**SAN LORENZO VALLEY WATER DISTRICT
CROSS COUNTRY PIPELINE CONSTRUCTABILITY
PEER REVIEW OF FREYER & LAURETA STUDY AND MEMO**

**Peer Review of March 2022 Study and
Draft Supplemental Evaluation Dated April 6, 2022**

24 NOVEMBER 2022
PROJECT NO. 12196

TYPICAL CROSS-SECTIONS FOR NARROW AND WIDE BENCH PER SLOPE CLASS 5-MILE AND PEAVINE WATER LINES

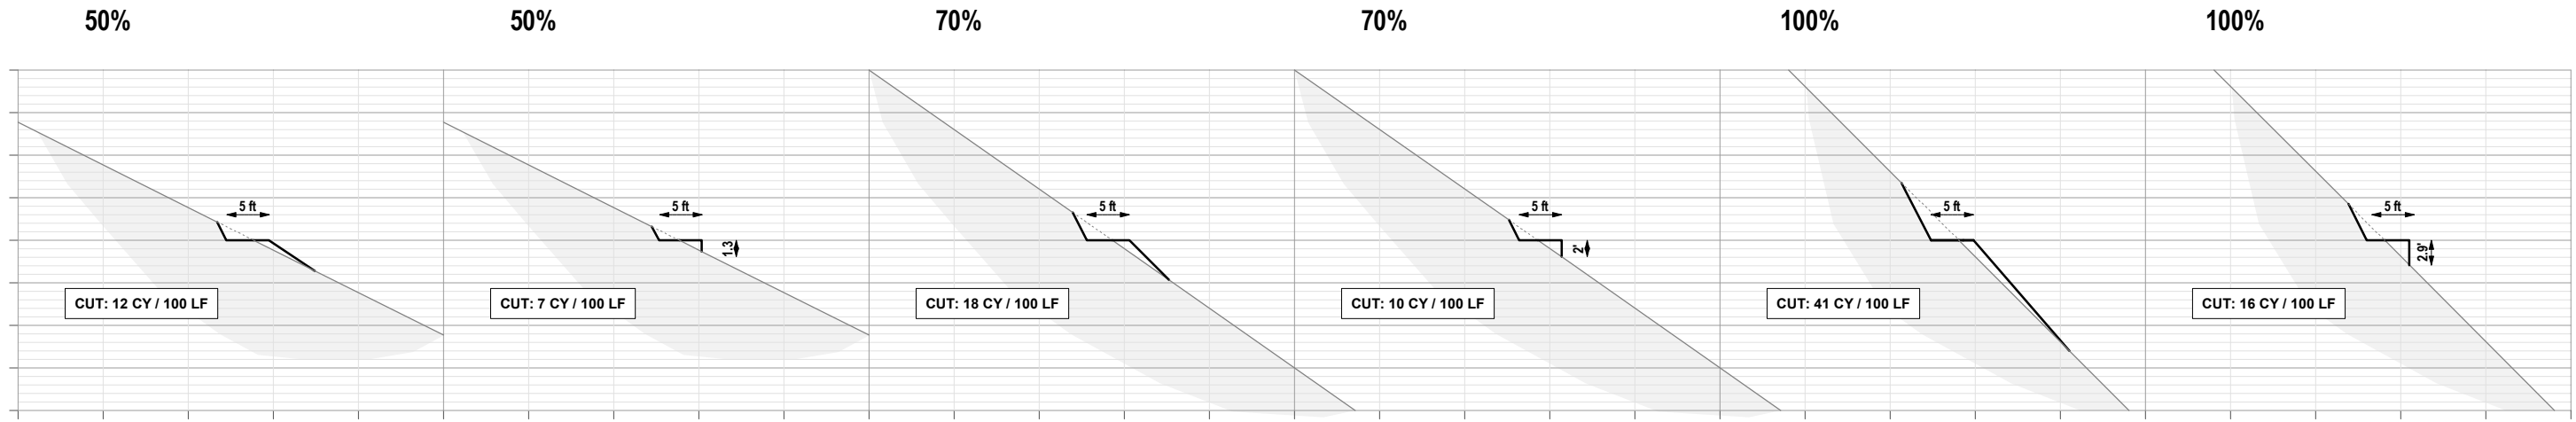
HKA examined Figure 3 in the F&L March 2022 STUDY. The cross sections presented are not to scale and thus could be misleading. We have redrawn Sections 1, 3, 4, 6, 7 and 9 to scale on 50%, 70% and 100% slopes and those are presented in Figure 5. As Table 1 shows, it is likely that 87% of the pipeline alignment crosses slopes over 50%, and 48% of the pipeline alignment crosses slopes that exceed 80%.

The cross sections in the HKA Figure 5 above illustrate the comparative difficulty of construction of 5 foot and 12 foot wide temporary construction benches to support a replacement pipeline. The utilize balanced cut and fill volumes, 0.5:1 (H:V) unretained cutslope concepts, either full retaining structures or thin sliver fills.

What Figure 5 indicates is that 4 to 6 times as much cut is required for a 12 foot wide bench

compared to a 5 foot wide bench. Taking into account both the linear footage of alignment across each slope class as presented in Table 1 and the associated retaining wall heights shown in Figure 5 indicates approximately 6 times as much retaining wall face footage is required for a 12 foot wide bench compared to a 5 foot wide bench. On average, average retaining wall heights on a 12 foot wide bench is over twice that required for a narrower 5 foot wide bench. What this means is very significant grading and engineered retaining walls will be required if a 12 foot wide bench is pursued. We note that retaining wall cost estimates are often not linear with retaining wall height ratios; taller walls have greater costs per square foot of wall face.

For a narrow 5-foot bench, we find that approximately one sixth retaining wall face footage will be required compared to a wider 12 foot bench, and the retaining walls that are needed will need to be less than half the height (See Figure 5 in Appendix A). In some areas, depending on geology, topography, and distance from a watercourse, it may be possible to limit the amount of retaining walls by building the bench out on temporary fill (possibly retained behind logs), then pulling back the oversteepened fill to cover the trench and pipe. This, of course, could only be done if equipment can get to these portions of the alignment, which as we have discussed earlier is questionable in many areas. Moreover, it has been our experience on small trail projects that the precise requirements for retaining walls cannot be predicted with certainty in advance and such walls are often “field fitted” based on actual conditions encountered and are dependent on the skill of the equipment operators.
